Docket Item # 2
BAR CASE # 2012-0416

BAR Meeting
January 23, 2013

ISSUE: Revisions to Previously Approved Plans
APPLICANT: Jorge & Lorie Nevares by Carter Jones, AIA
LOCATION: 114 North Patrick Street
ZONE: CD / Commercial

New Elevations
 24 December 2012
 3/16" = 1'-0"

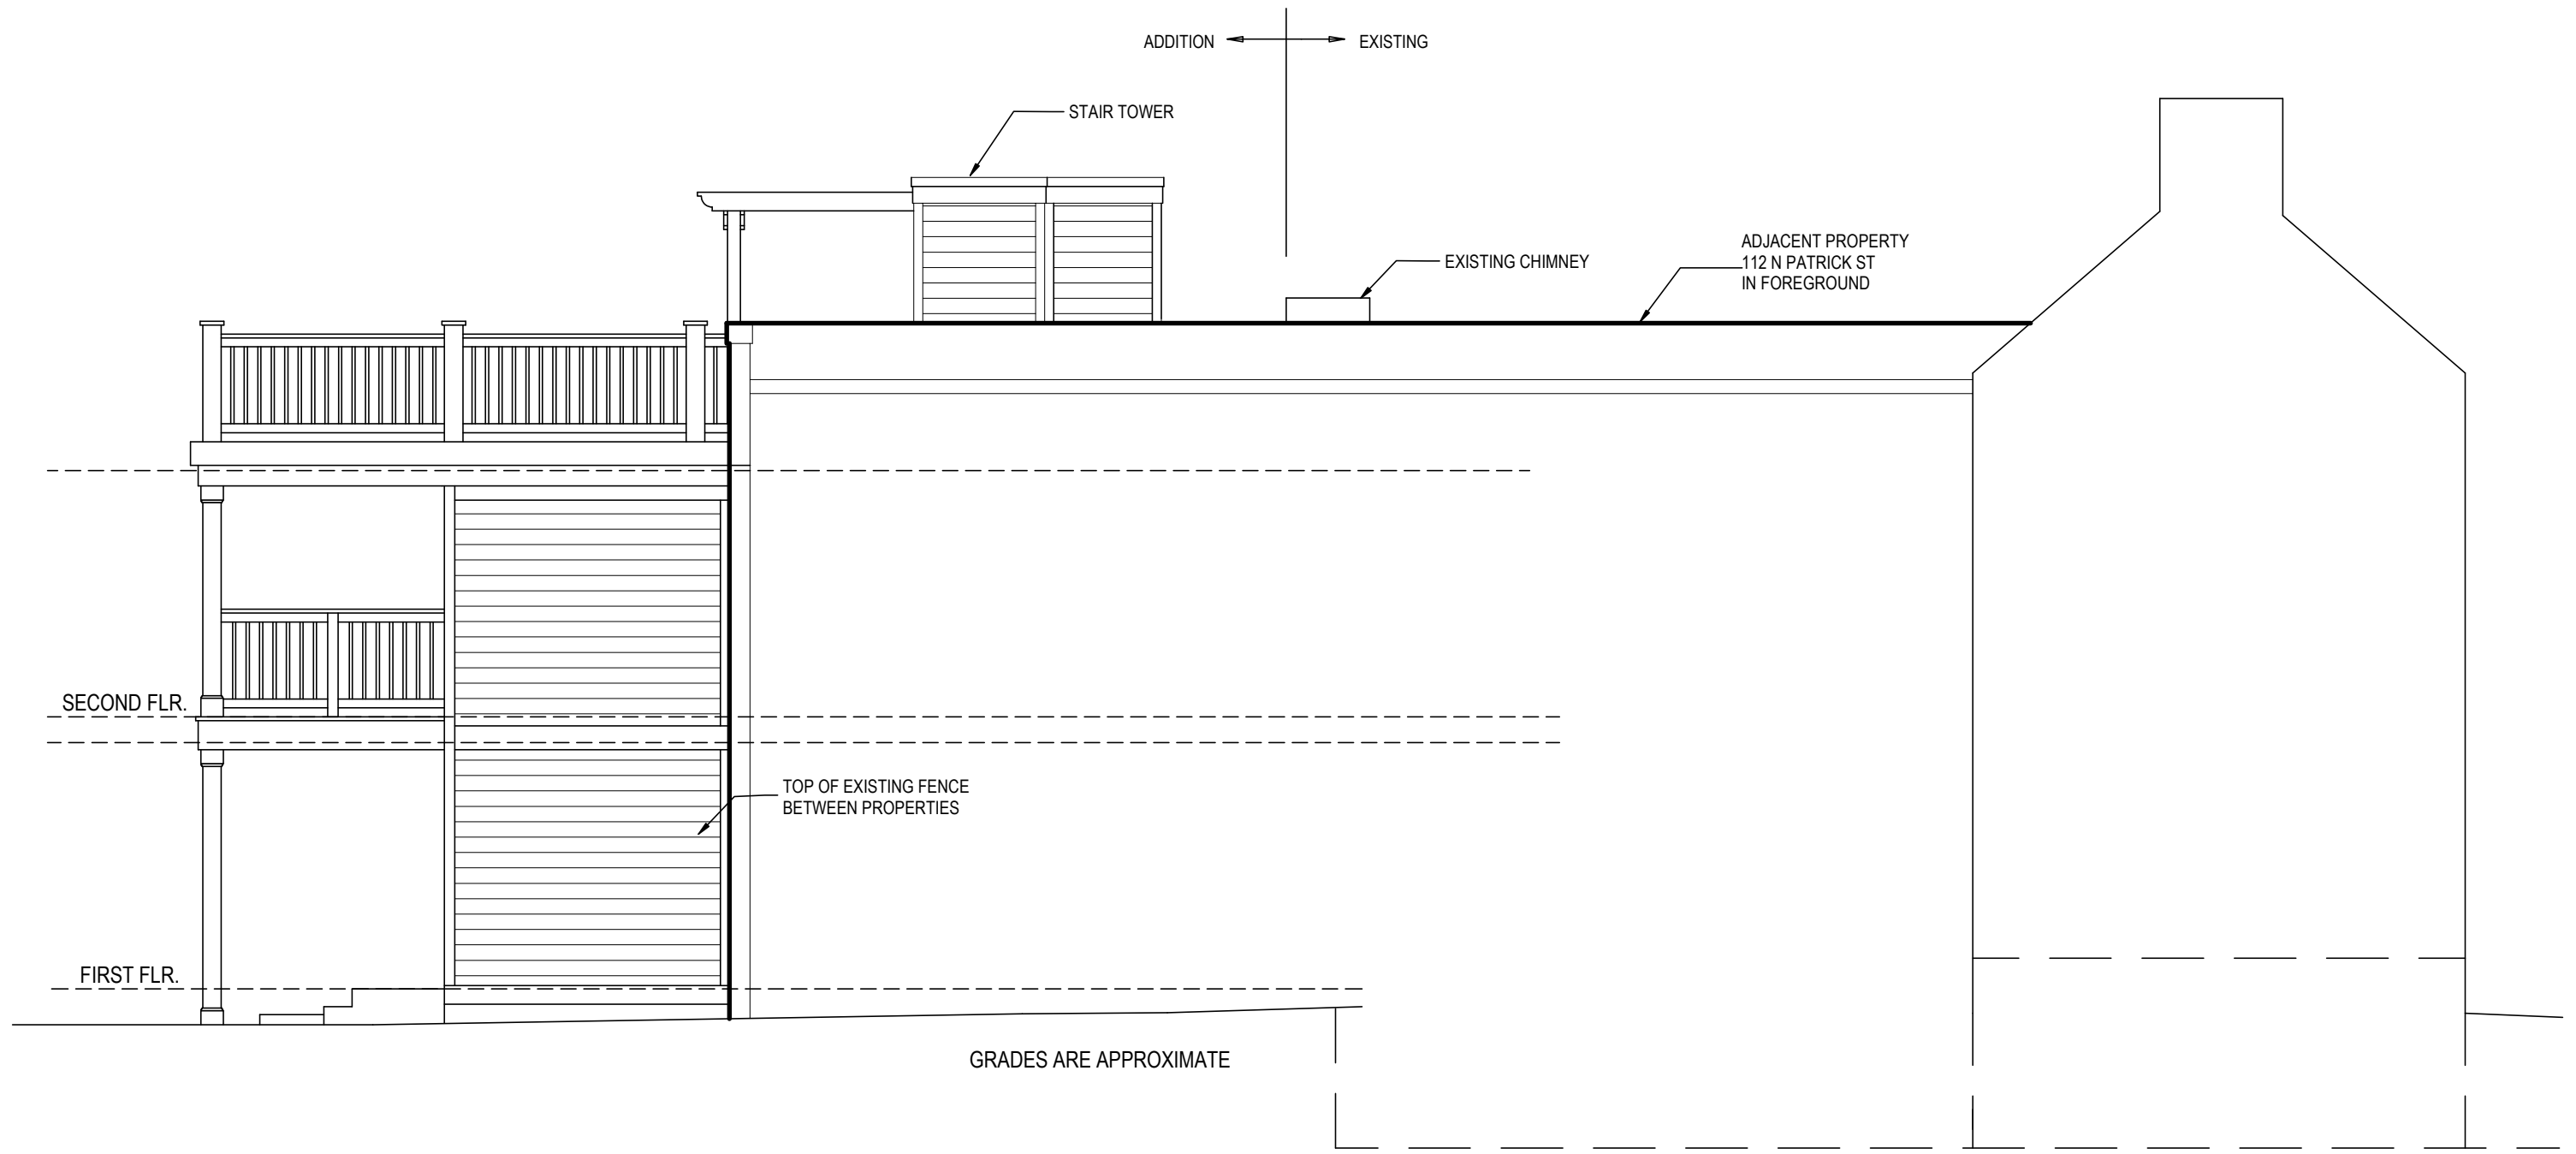
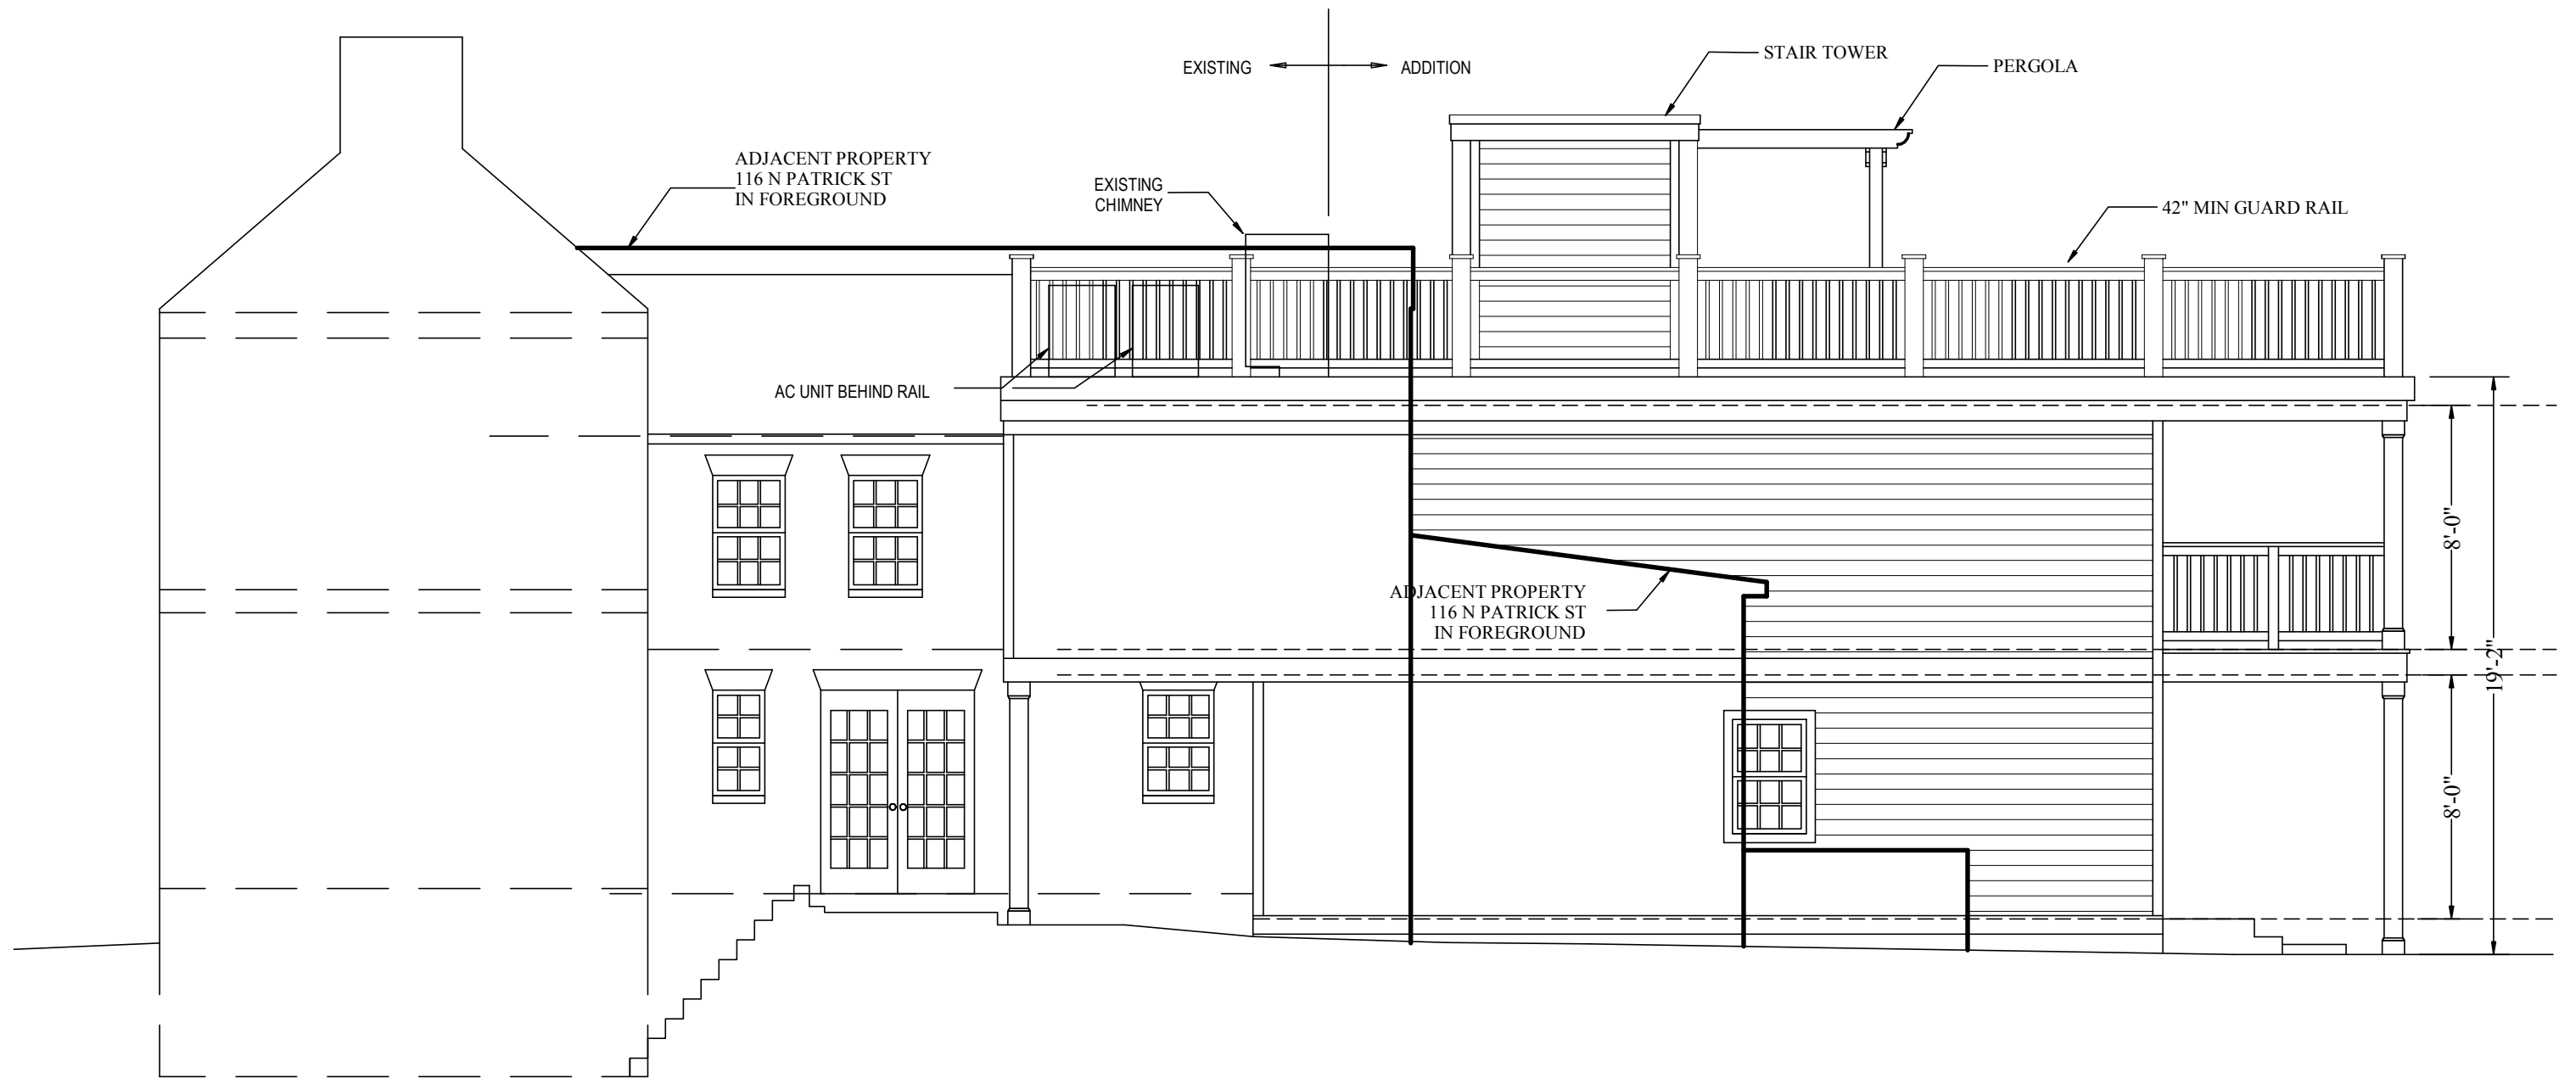
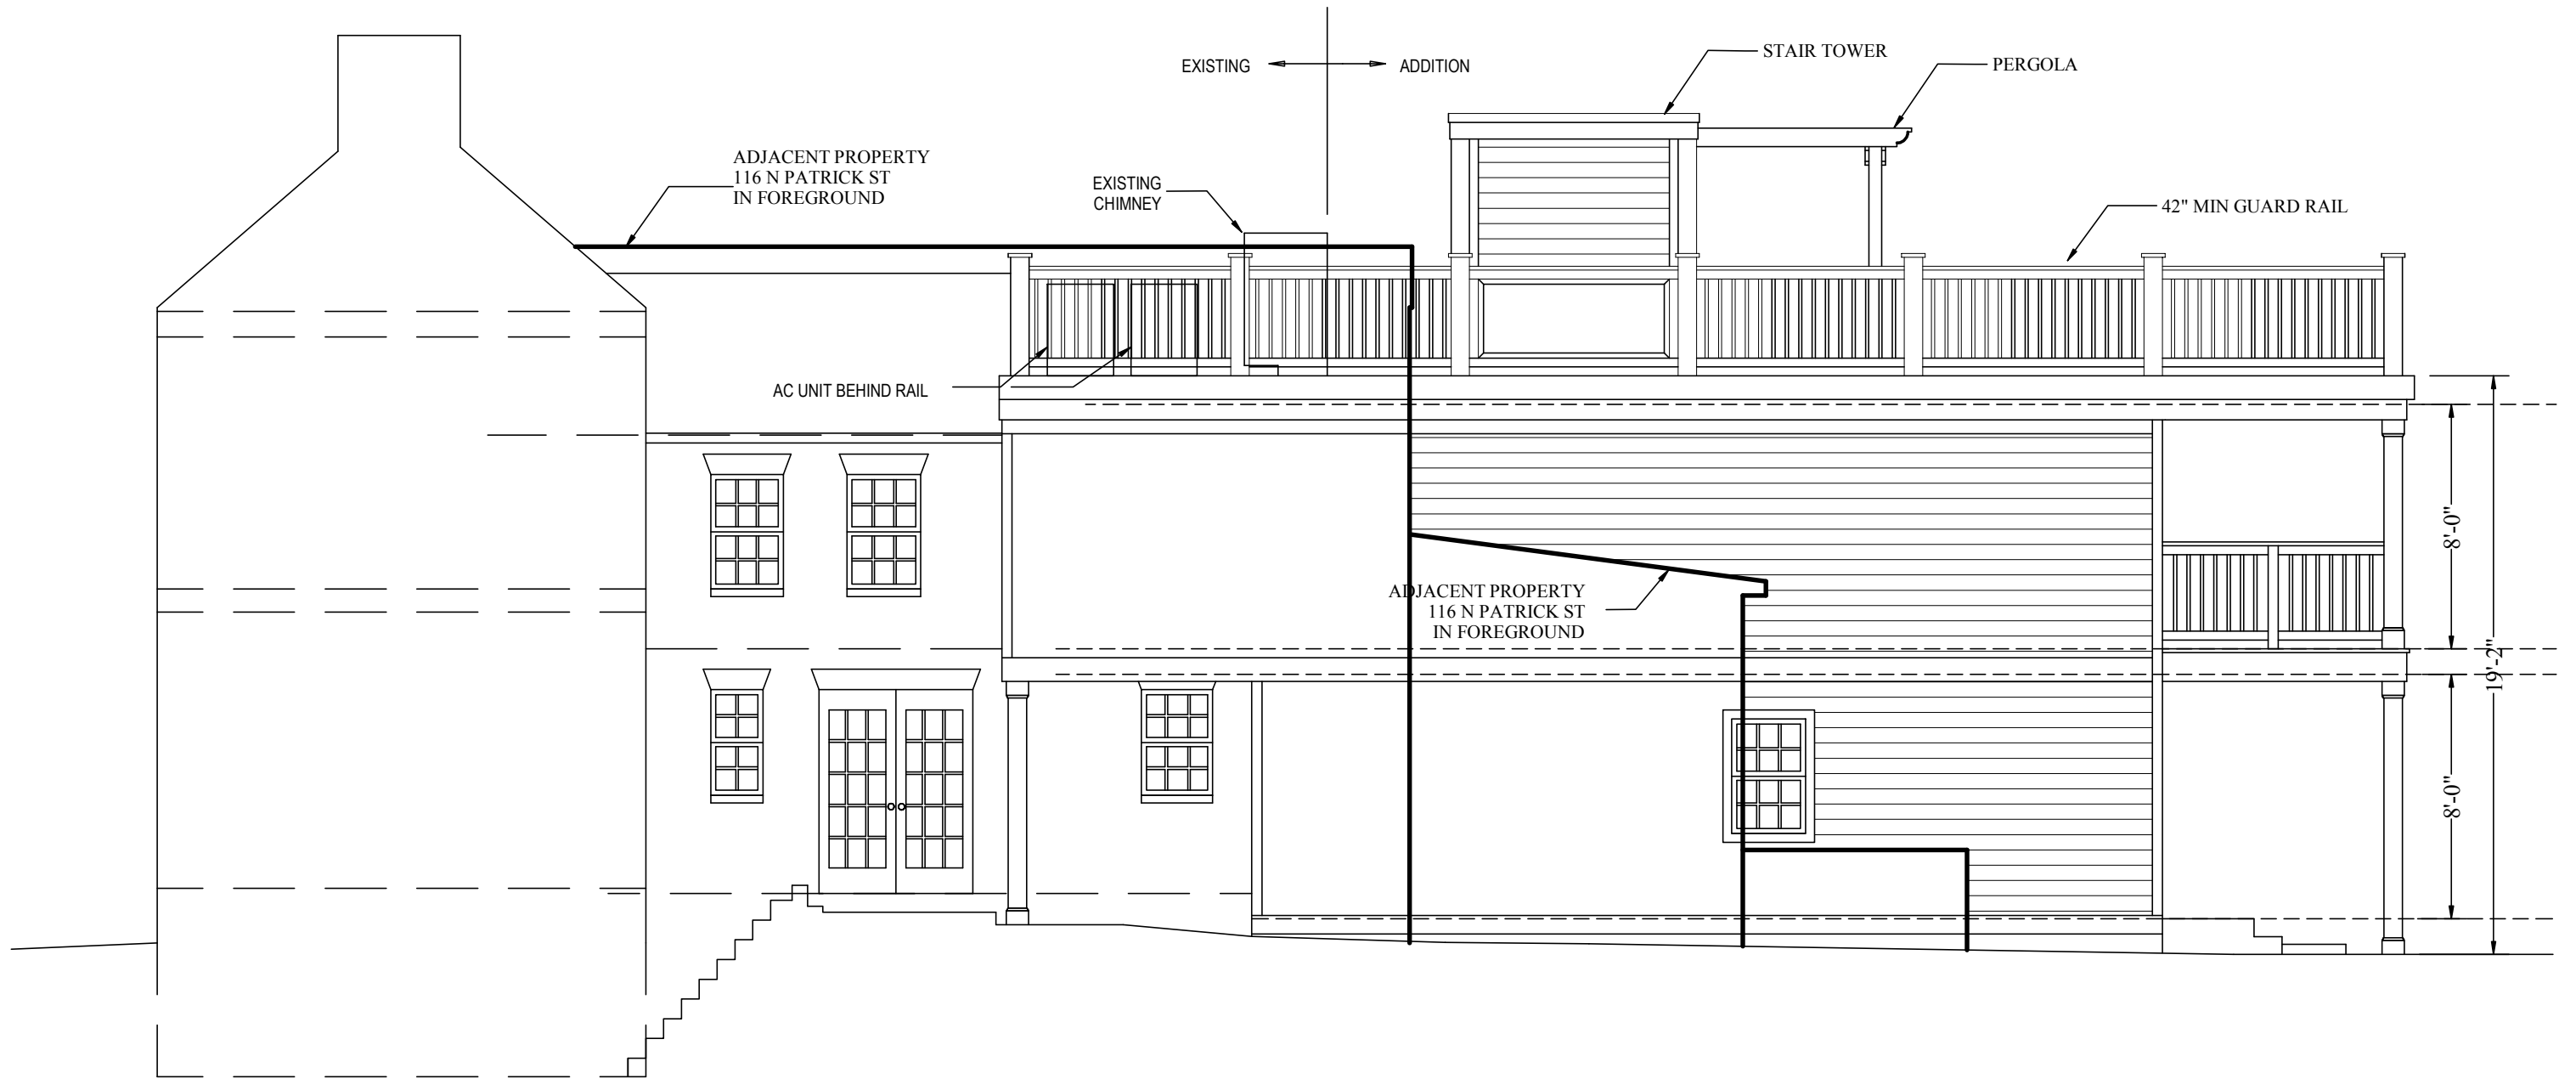
The previous BAR application for this property suggested a roof deck with the rooftop balustrade but did not specifically call out the presence of a roof deck. In recent years, the two BARs have seen an increase in the request for roof decks as property owners seek to create more outdoor space. The *Design Guidelines* state that “roof decks should be constructed so that they do not interfere with the historic roofline of a building” and “material should not be used on a roof deck that detracts from the historic architecture of a structure.” In this particular case, Staff believes that the roof deck stair tower and pergola will be minimally visible due to the mid-block location of the subject property and the location of the stair tower set back from the rear of the addition. While there will be some visibility from the public alleys, Staff does not believe that the addition will detract from buildings of historic merit.

Although not specified on the plans, it is understood that the proposed materials for the roof deck stair access and pergola must match the materials approved for the addition which include smooth fiber cement siding and trim and a painted Trex composite railing.
